STAFF RECOMMENDATION

1806 Shelby Avenue

February 17, 2021

Application: New Construction—Addition

Figures 3 and 4: (left) shows the existing outbuilding and (right) is the 1957 Sanborn map where the outbuilding does not appear.

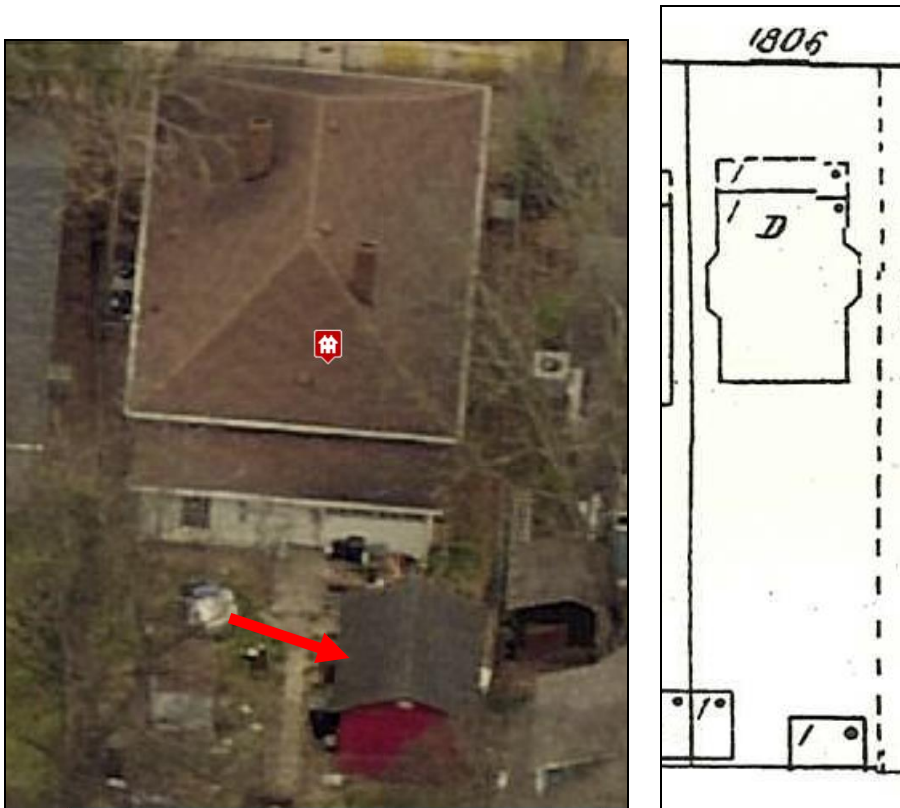
Partial Demolition: The applicant proposes to demolish an existing outbuilding (Figure 3). The date of construction for the outbuilding is not known, but it does not appear on the 1957 Sanborn Map (Figure 4). Staff therefore finds that its date of construction does not meet the area's period of significance and it is non-contributing. The demolition of the existing outbuilding is appropriate demolition under the design guidelines.

Figures 5 and 6: (left) is the c. 1968 PA photo and (right) is the proposed front façade.

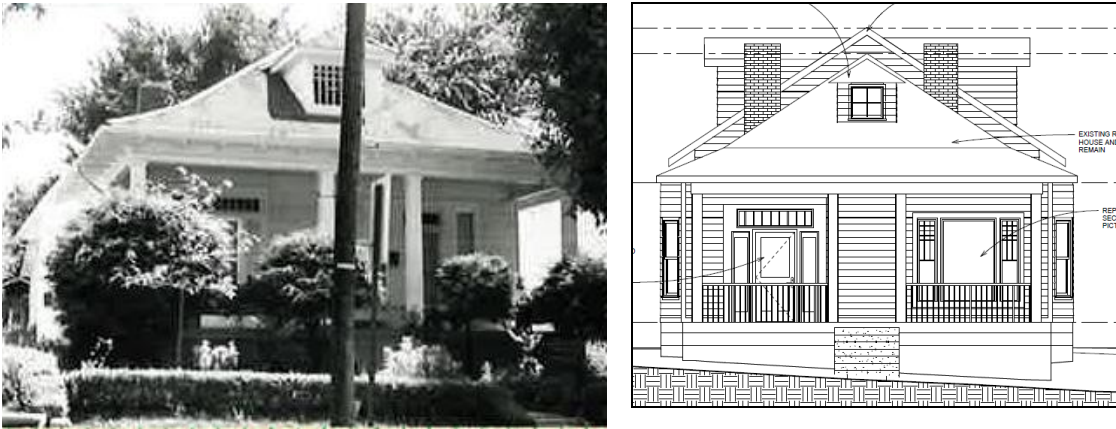
The applicant also proposes to alter a door opening on the front façade, which is considered partial demolition. The front façade has two entries to the front porch. The left entrance is historic, while the right one is not (Figures 1 & 2). The c. 1968 Sanborn map does not show in detail what the opening looked like historically (Figure 5). The applicant intends to remove the front door opening and replace it with a window in between the existing side windows (Figure 6). Staff finds this to meet the design guidelines because the existing door opening is not historic and the new window opening is a good approximation of what was likely there historically. Staff therefore finds this to be appropriate demolition.

Figure 7 shows the overlapping eaves.

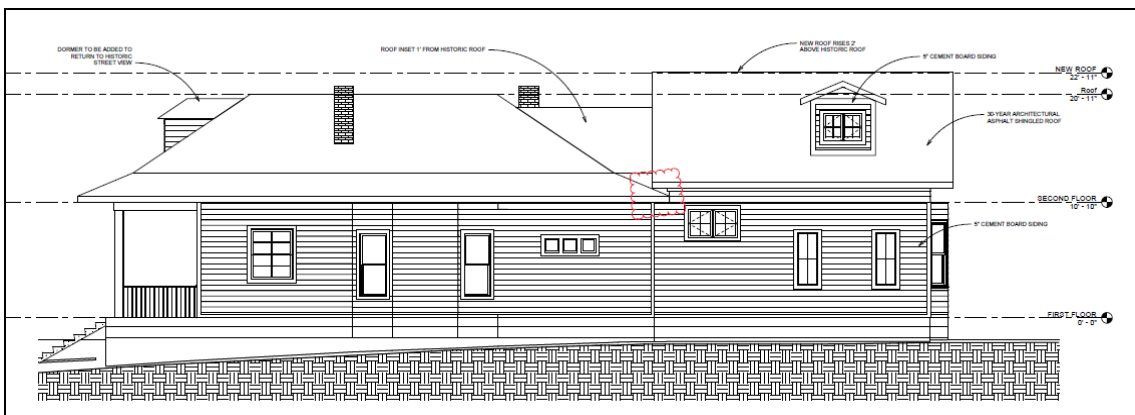
Height & Scale: The applicant is proposing a one-and-a-half story addition behind the historic house, which is also one-and-a-half stories. The addition will be two feet (2') taller than the historic house, which meets the design guidelines. The foundation height will match that of the historic house. The eave height will be approximately one foot (1') taller than the historic house, which staff finds could be appropriate since the entirety of the addition is inset one foot (1') from the side walls of the house. However, staff recommends that the connector roof piece of the addition be lengthened by two or three feet (2'-3') so that there is more room between the eave of the historic house and the eave of the gabled portion of the addition on the side facades (Figure 5).

The addition connects to the historic house with an 8/12 gable connector that is lower in height than the historic house. As previously mentioned, staff recommends elongating this section so that there is more space between the eaves of the historic house and the taller portion of the addition. The main form of the addition will have an 8/12 front facing gable. Staff recommends that this front facing gable be clipped to meet the design guidelines.

1 FRONT ELEVATION
1/4" = 1'-0"

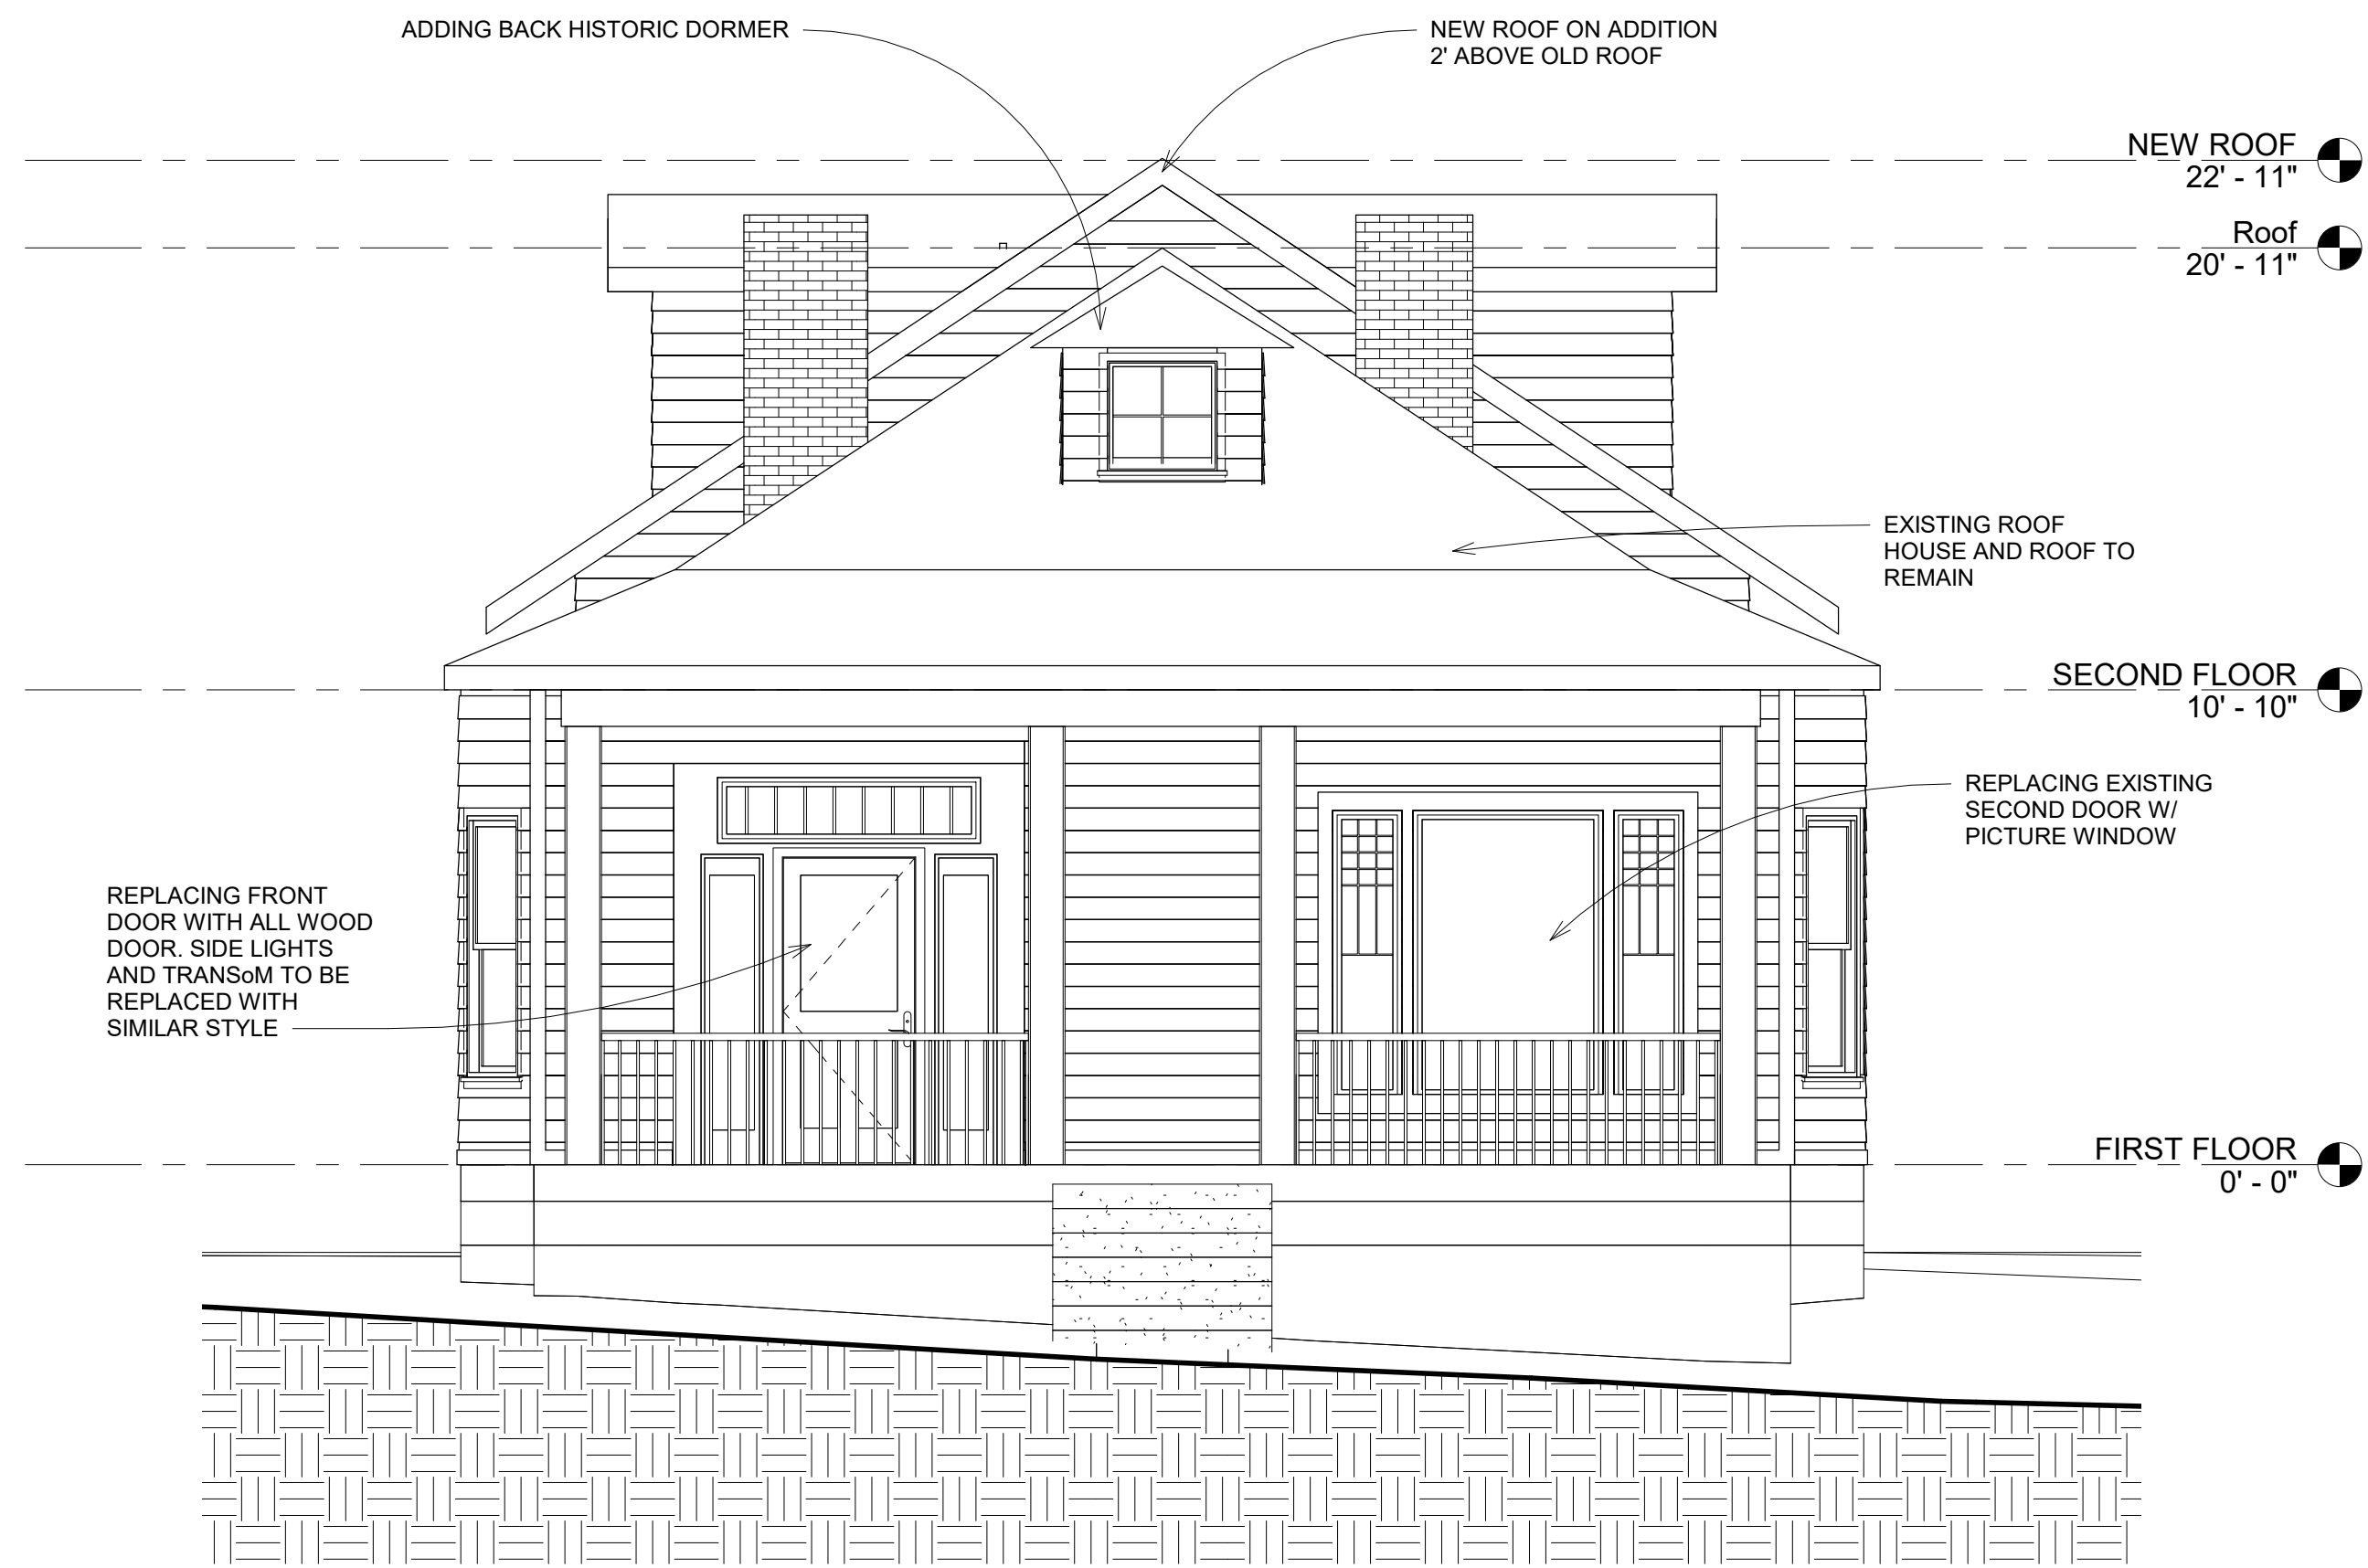
Roof form: The applicant intends to add back the hipped roof dormer that is seen in the older photographs. Staff recommends that the window opening be larger so that the front face of the window is all window and trim without any siding.

1. The front-facing gable be clipped;
2. The connector piece be elongated by approximately three feet (3') to provide more space between the eave of the addition and eave of the historic house;
3. The window in the dormer be enlarged to cover, with just trim, the front face of the dormer;
4. Staff approve all windows and doors and the roof shingle color; and,
5. Staff approve the location of the HVAC and all utilities.
